CITY OF KIRKWOOD

SUBJECT: PZ-16-20; 608 E. Monroe Ave. – 3lot Subdivision
Preliminary & Final Plat

SUBJECT: PZ-15-20; 11204 -- 426 N. Kirkwood Road -- Kirkwood Flats
B-2 Mixed Use Preliminary Development Plan

DRAWN BY: J.F.B.	ORDER NO. 18-070	SHEET 1
CHECKED BY: M.A.S.	DATE 10/21/2019	1

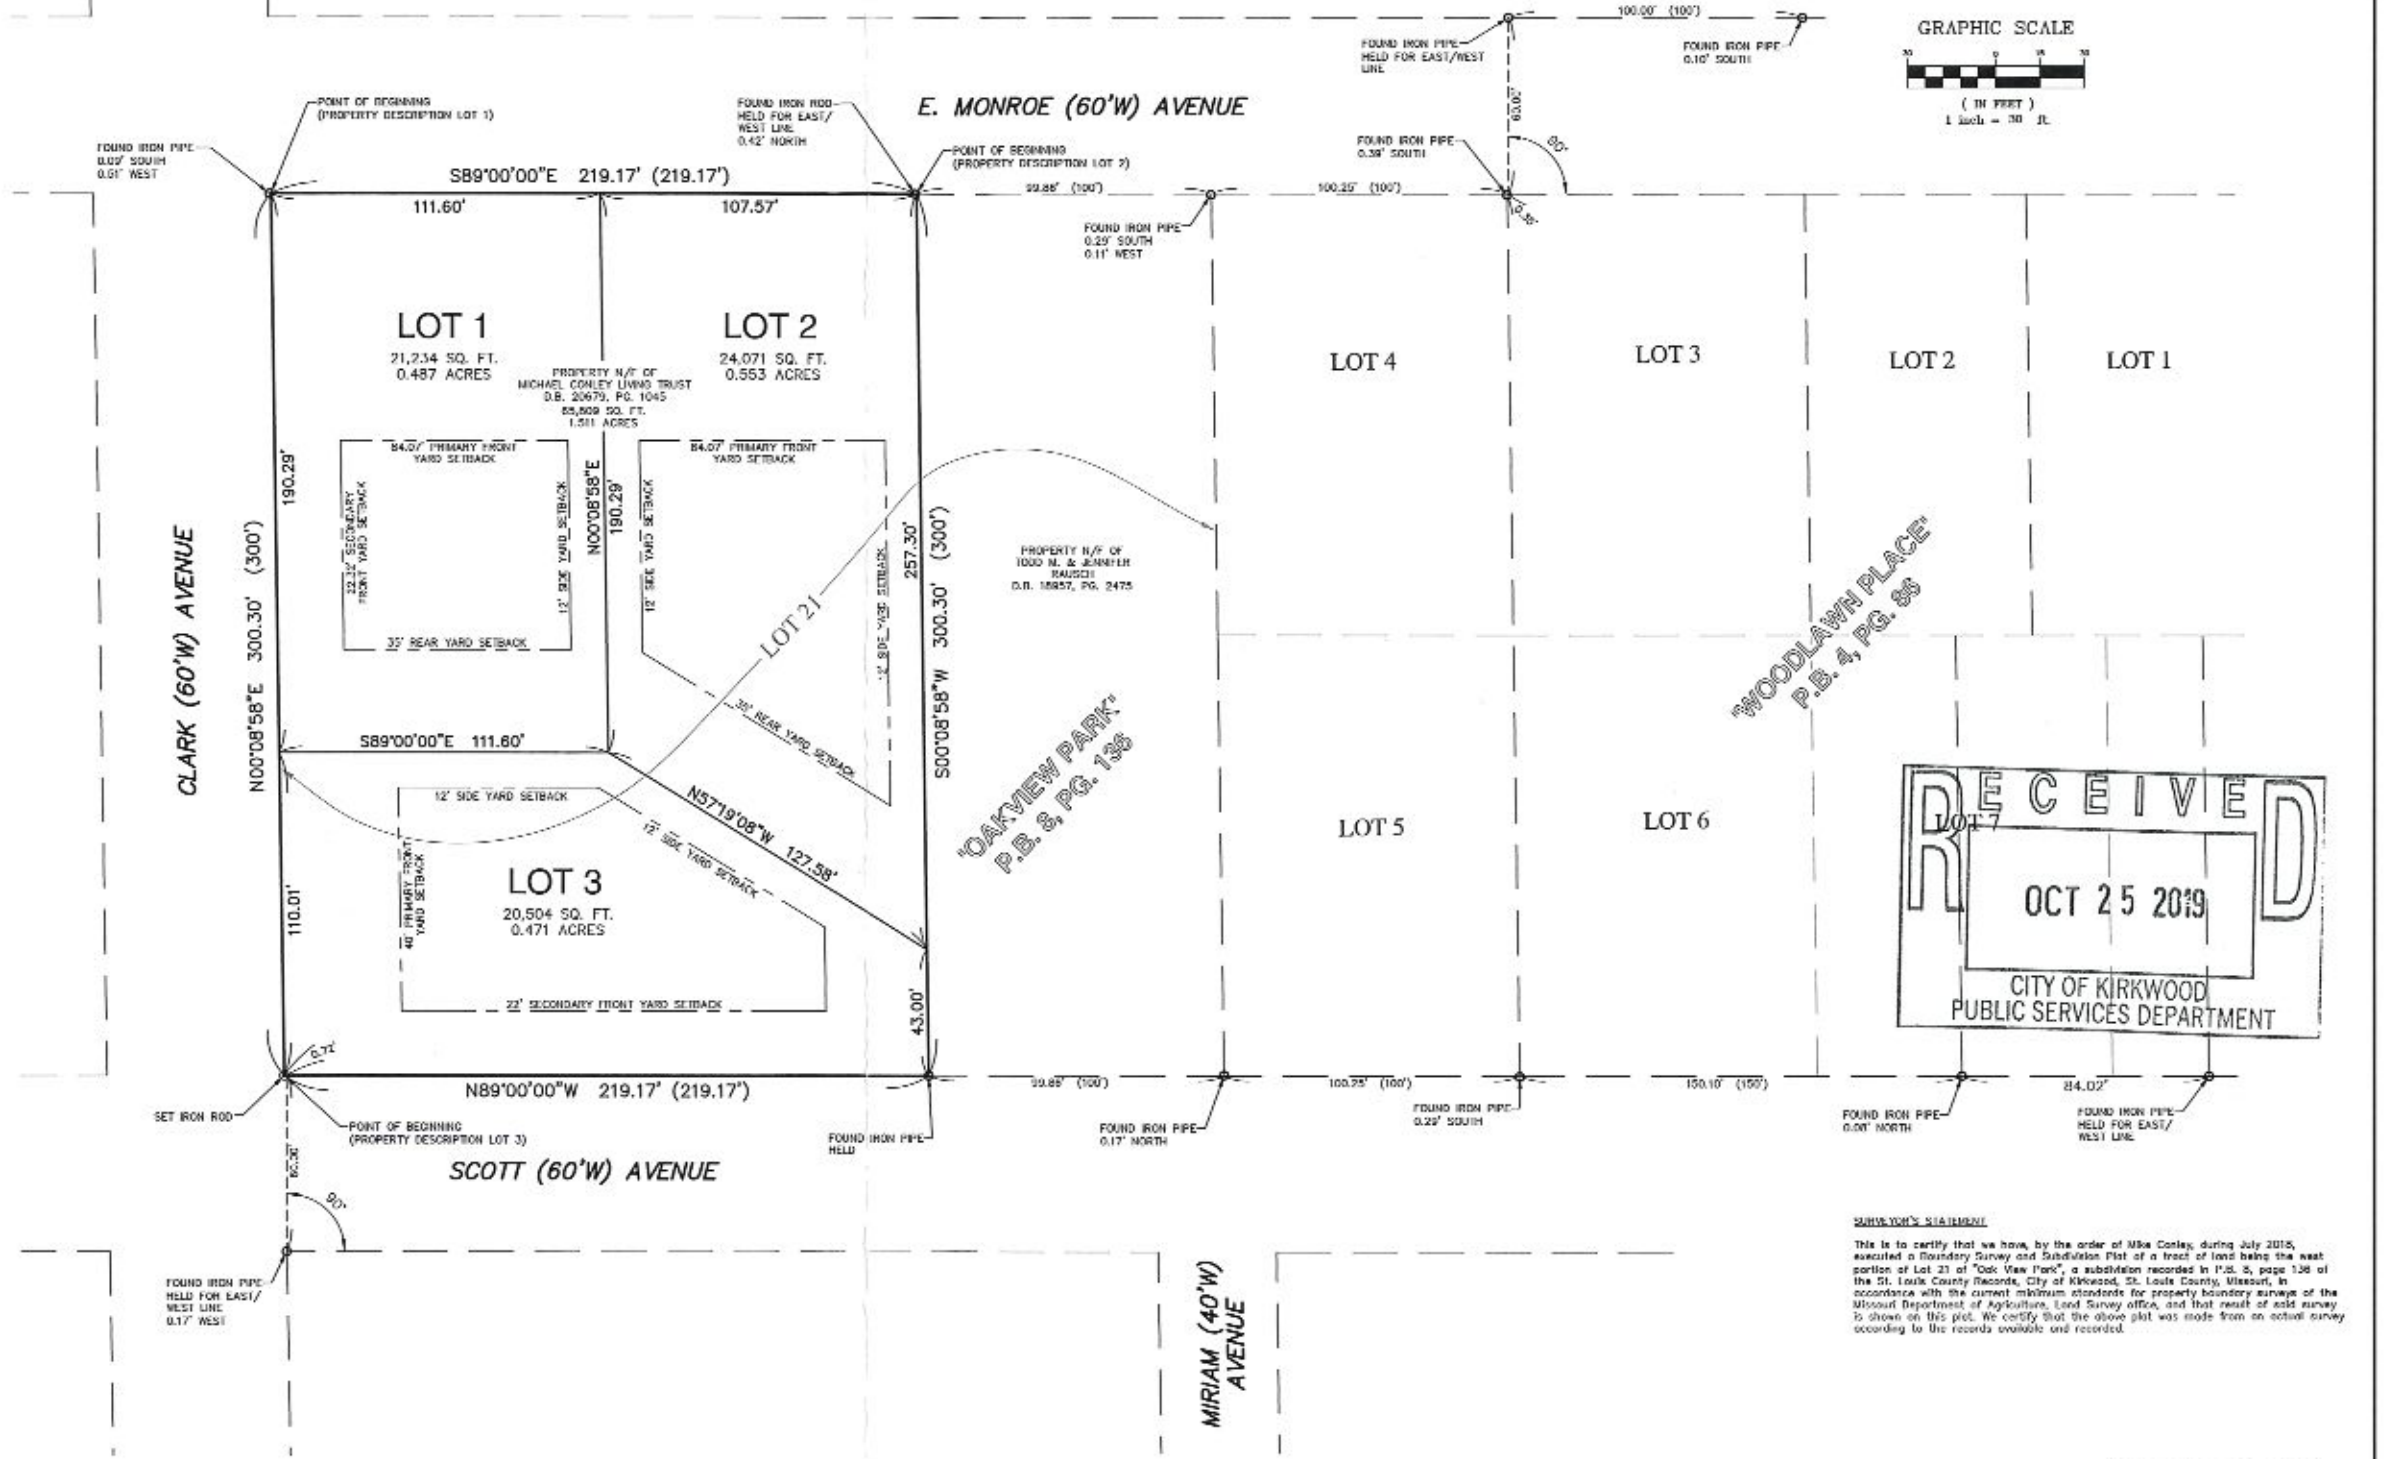
1. Add the Section, Township, and Range to the title block.
2. The subject property's referenced subdivision of Lot 21 of Oak View Park does not match the City's records. Our records indicate this is Lot 21 of East Kirkwood (see attached plat). Revise all references regarding this.
3. The adjacent referenced subdivisions also do not match City records. See the attached plats and revise the final plat to accurately reflect the boundaries of East Kirkwood, Woodlawn Place, and Oak View Park.
4. Note, additional utility easements may be required after review from other City departments. If easements are required, the City's easement script shall be added to the plat along with delineated easements locations.

A Hackberry *Celtis occidentalis* Fair

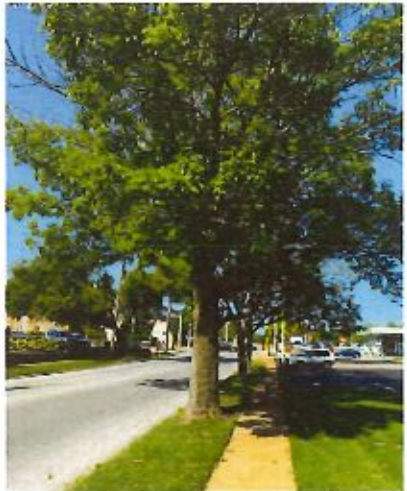
14. Off-site trees must be preserved. Tree "A" on the adjacent gas-station property is noted as having tree protection recommended, but it is also listed as not to be saved. Revise the preservation plan and notes to be consistent with preservation of this tree and all off-site trees.

Sheet Number
C-0.2

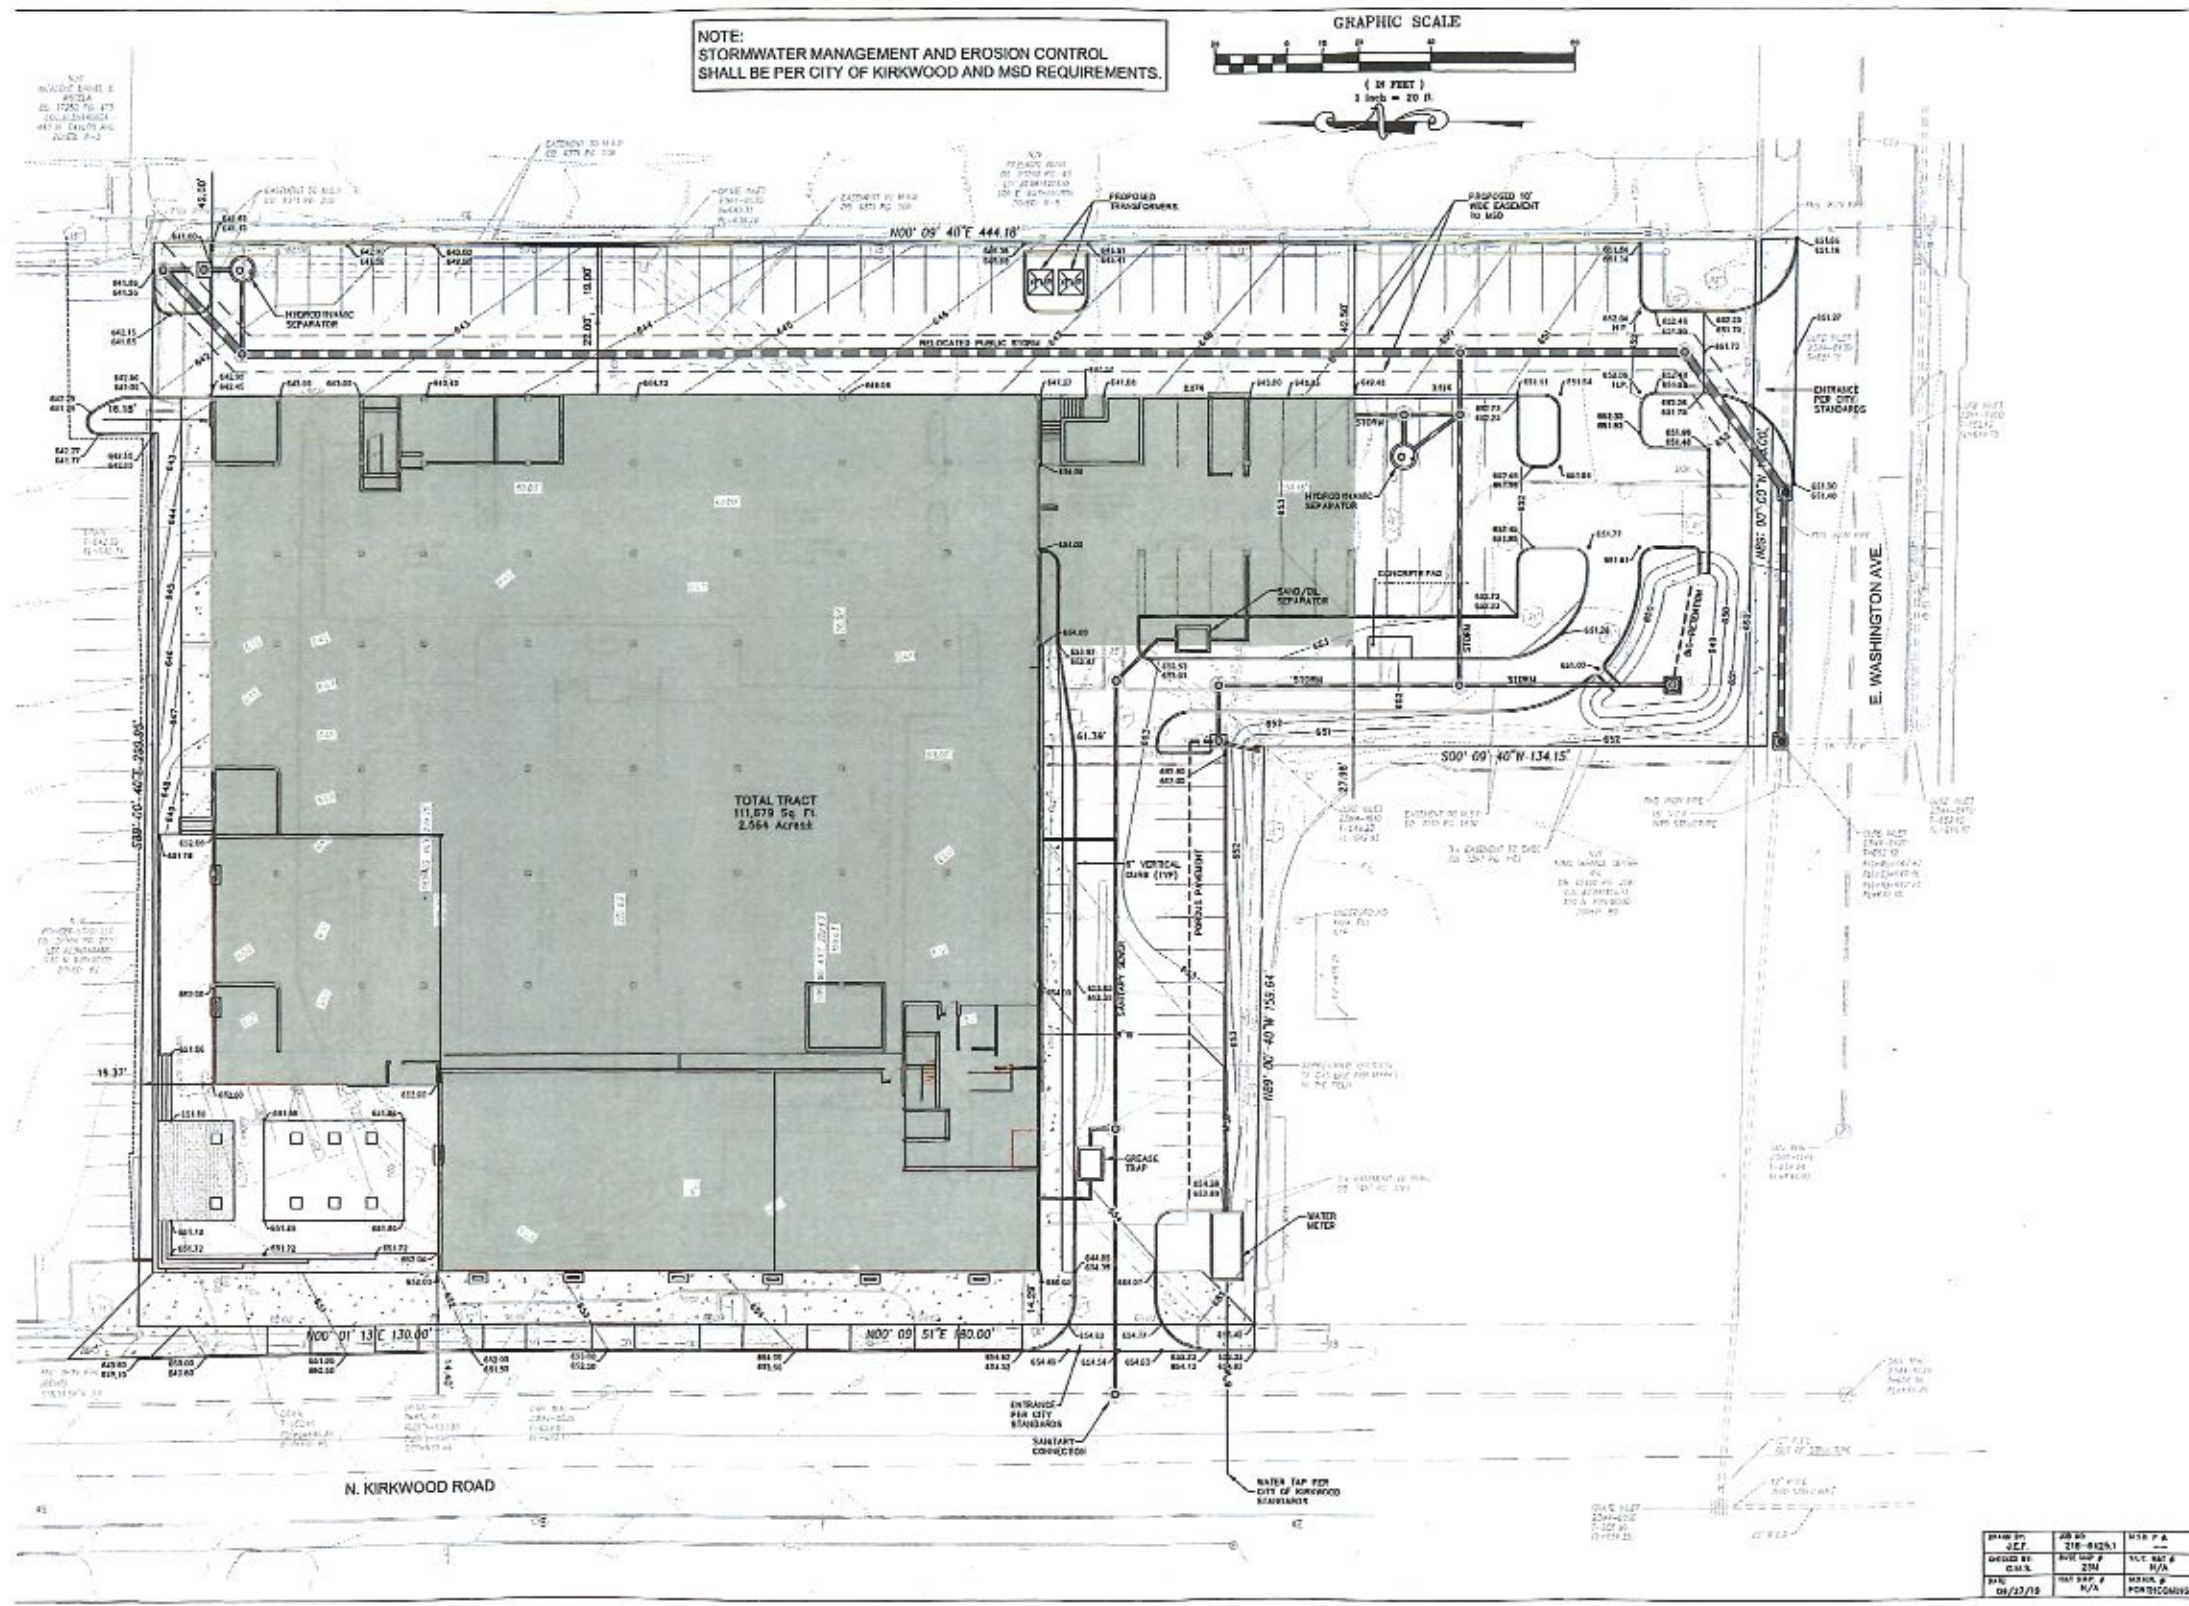
10. The Street Frontage Occupation requirement along Kirkwood Road is 75% for this location. All building that is within 51' of the Kirkwood Road right-of-way are permitted to be included in this calculation. Currently, only 167 linear feet of the building is located within the maximum 51' setback from Kirkwood Road. This is only 53.8% of the 310' frontage. Revise the plans or add a modification for this requirement to the request letter.

11. The proposed 6' tall sight-proof fence is shown on the Landscape Plan, but should be indicated on the proposed Site Plan. This fence is the minimum to meet the B-2 buffer requirement.

12. ADA accessible parking shall be provided per Section 1000.5. The Site Layout exhibits indicate adequate ADA spaces. The Site Plan must be updated to include this information.

13. The Traffic Impact Study recommends that the Kirkwood Road access be limited to a right-in/right-out access point. This restriction should be incorporated into the Site Plan.

East Elevation 1/32" = 1' - 0"

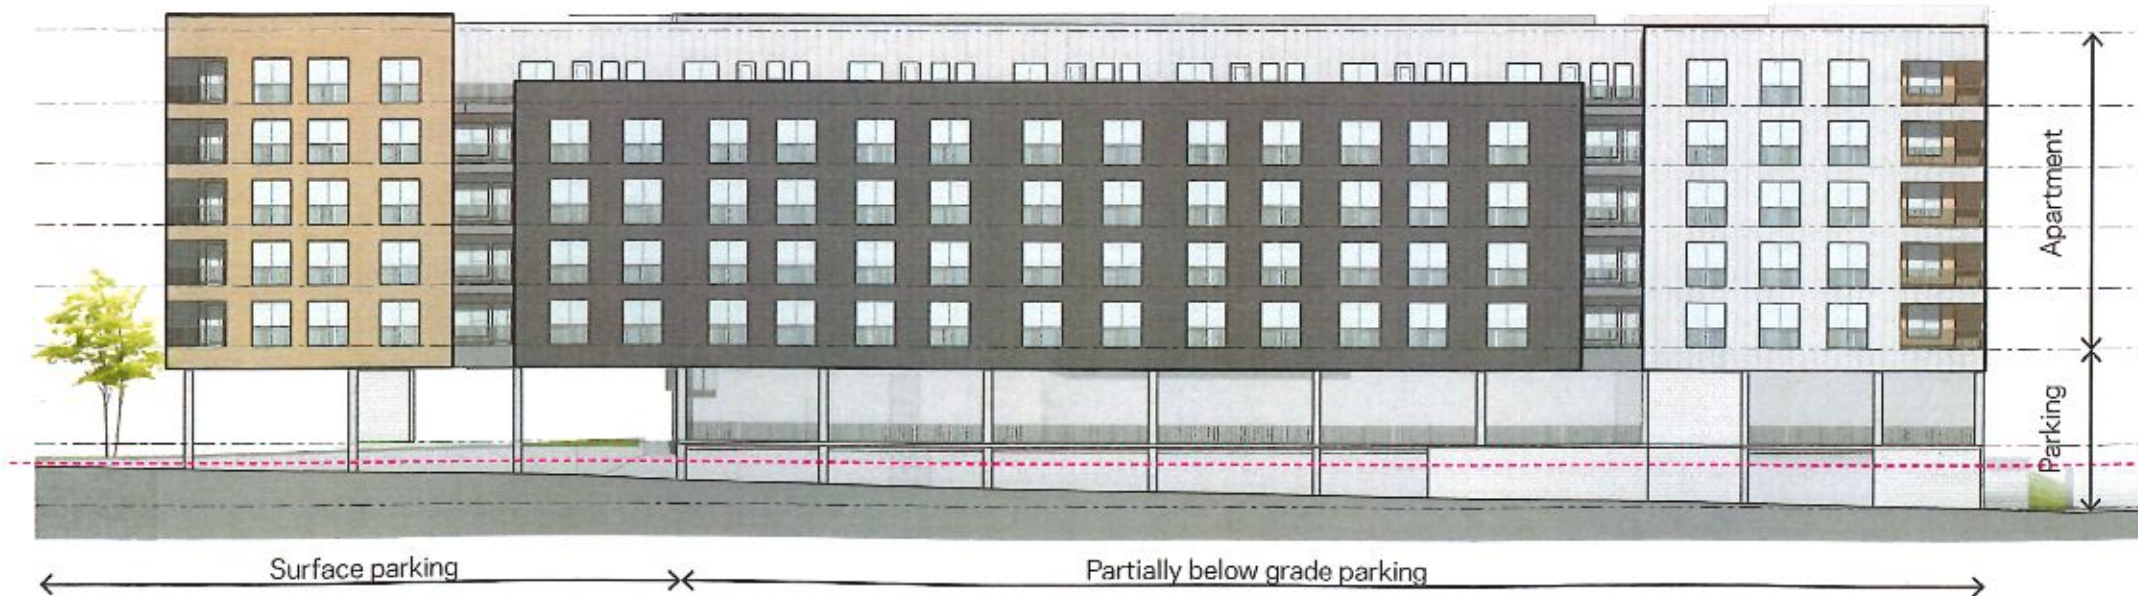
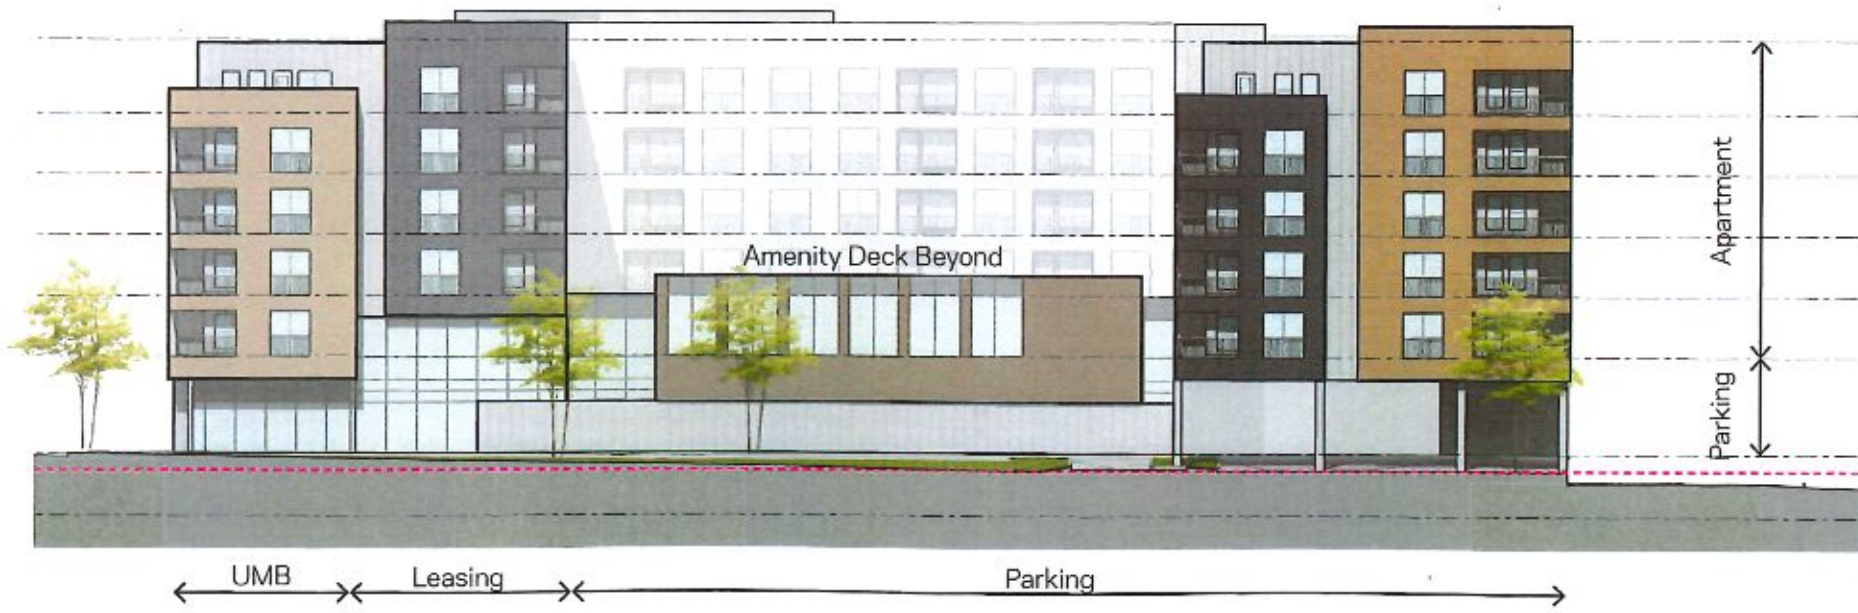
roof. The building elevations show 650' as the average proposed finished grade but the line does not appear to be the average of all facades. Provide confirmation of the average proposed grade calculation and revise the elevations as needed.
